JOINT REGIONAL PLANNING PANEL (Northern Region)

JRPP No	2015NTH002
DA Number	T6-14-62
Local Government Area	Kempsey Shire
Proposed Development	Staged development application – ‘Saltwater’ residential subdivision concept plan (approximately 338 lots) and Stage 1 of the concept plan (29 lots)
Street Address	32 Waianbar Avenue, South West Rocks
Applicant/Owner	Applicant – Teebee Holdings Pty Ltd Owners - Teebee Holdings Pty Ltd Kempsey Shire Council
Number of Submissions	44
Regional Development Criteria (Schedule 4A of the Act)	<p>The proposed development is of a kind listed at Clause 9 of Schedule 4A to the EP&A Act 1979:</p> <p><i>‘...subdivision of land for residential purposes into more than 100 lots where the land is wholly or partly in a sensitive coastal location.’</i></p> <p>Therefore, pursuant to clauses 20, 21 and 22 of <i>State Environmental Planning Policy (State and Regional Development) 2011</i>, the regional planning panel is the relevant consent authority for this application.</p>

<ul style="list-style-type: none"> • NSW Department of Primary Industries – Water Submission • Independent review of ecological assessments
Recommendation	That development application T6-14

Figure 5: Concept master plan provided in Annexure B to additional information submitted dated 19 June 2015 (Geoff Smyth & Associates).

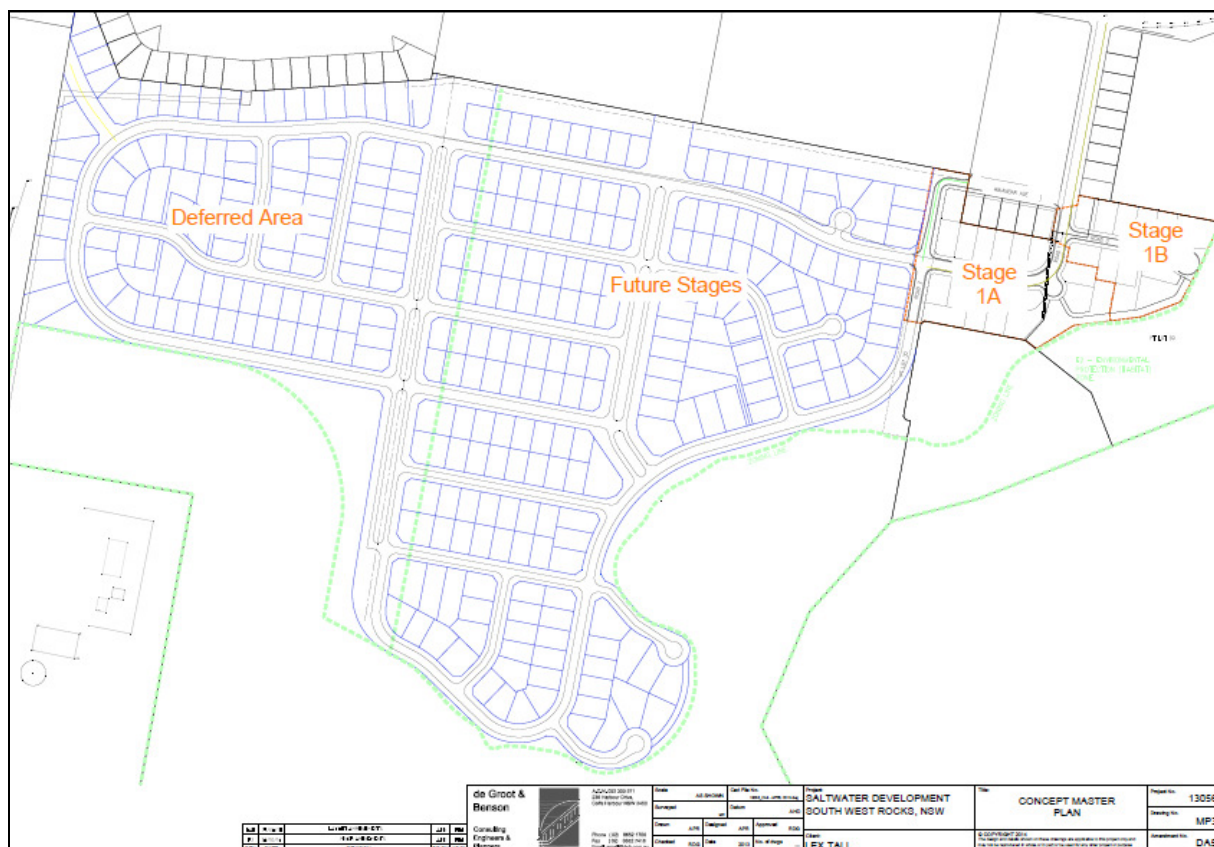
The submitted 'Coastal Village Masterplan' (see Figure 4) shows sporting fields located within the E2 zone adjacent to the golf course and sewage treatment plant to the west of the subject site. However, more recently submitted plans for the concept master plan do not show any development in this area (see Figure 5).

The same 'Coastal Village Masterplan' (see Figure 4) shows a neighbourhood centre (comprising of commercial premises and information and education facilities) adjacent to the sporting fields in the RU2 zone. These facilities are also not shown on the most recently submitted concept master plan (see Figure 5).

Nonetheless, 'recreation facilities' are prohibited under KLEP 2013 in the E2 zone and there would not be the ability to grant consent to this aspect of the concept plan.

Nonetheless, commercial premises and information and education facilities are prohibited under KLEP 2013 within this zone and there would not be the ability to grant consent to this component of the concept plan.
